Application for Planning Permission for Proposed Temporary Green Fuel Station for Electric Private Vehicles with Ancillary Facilities for a Period of 3 Years at Lots 1343RP(Part), 1356RP in D.D. 78 and Adjoining Government Land, Lin Chuk Road, Ta Kwu Ling North, N.T.

(Application No. A/NE-TKLN/124)

Table 1: Responses to Comments from Government Departments on Planning Application No. A/NE-TKLN/124 (1 June, 2026)

Drainage Proposal in support of
Planning Application No. A/NE-TKLN/124
for Temporary Green Fuel Station for Electric Private Vehicles with
Ancillary Facilities for a Period of 3 Years
at Lots 1343 RP (Part), 1356 RP in D.D. 78
and Adjoining Government Land, Lin Chuk Road, Ta Kwu Ling North,
New Territories

| 1: 1000 - A3 | FIGURE D4 |

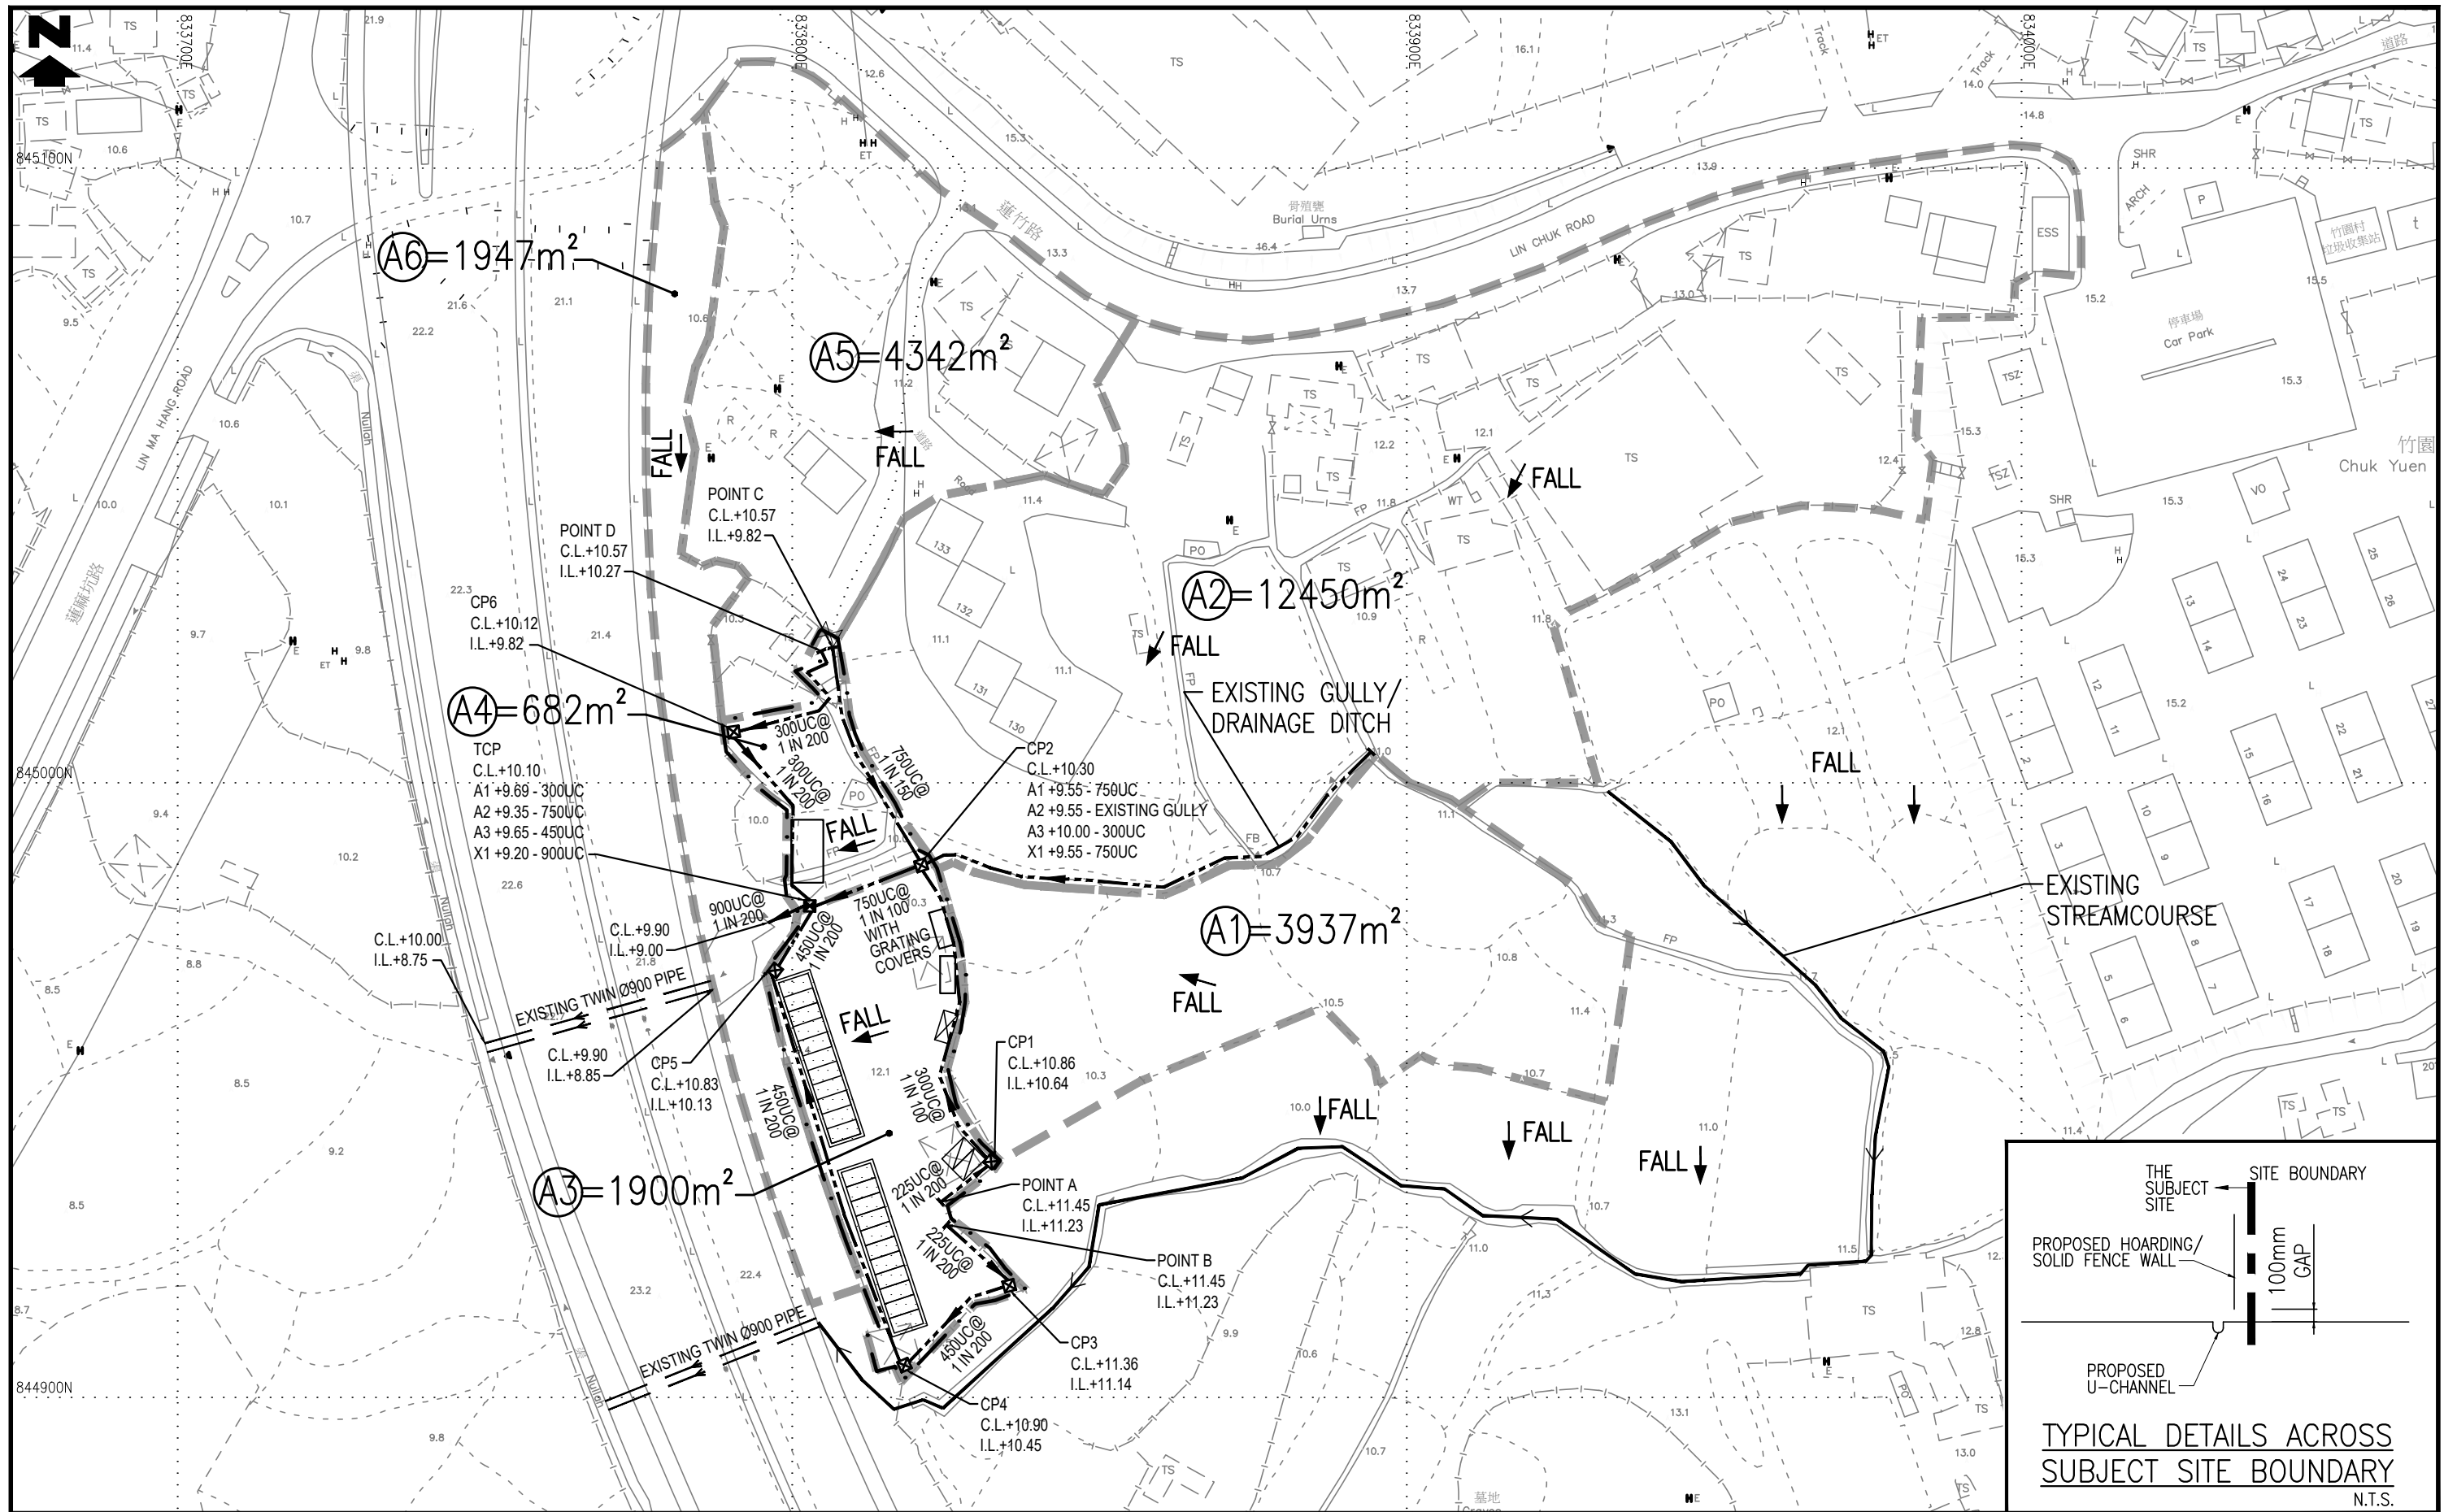
| COMMENTS | | RESPONSES |
|--|---|---|
| (1) | It appears that a pond and a drainage channel situated within the site would be filled/adversely affected by the proposed use. Unless the applicant can submit a satisfactory drainage proposal to mitigate the possible drainage impacts arising from the proposed use to my satisfaction, I do not support the application. | The Applicant's consultant has prepared a Drainage Proposal (see Annex 1) for consideration by DSD. |

- 4.2 Peripheral channels are proposed at the subject site to intercept overland flows across the subject site boundary. Besides, in order to ensure no surface runoff from the surroundings flowing towards the subject site, if occurs, being obstructed, 100mm high gap will be formed at the bottom of solid security hoarding/fence, when erected, along the subject site boundary. A Proposed Stormwater Drainage Layout Plan is shown in **Figure D4**.
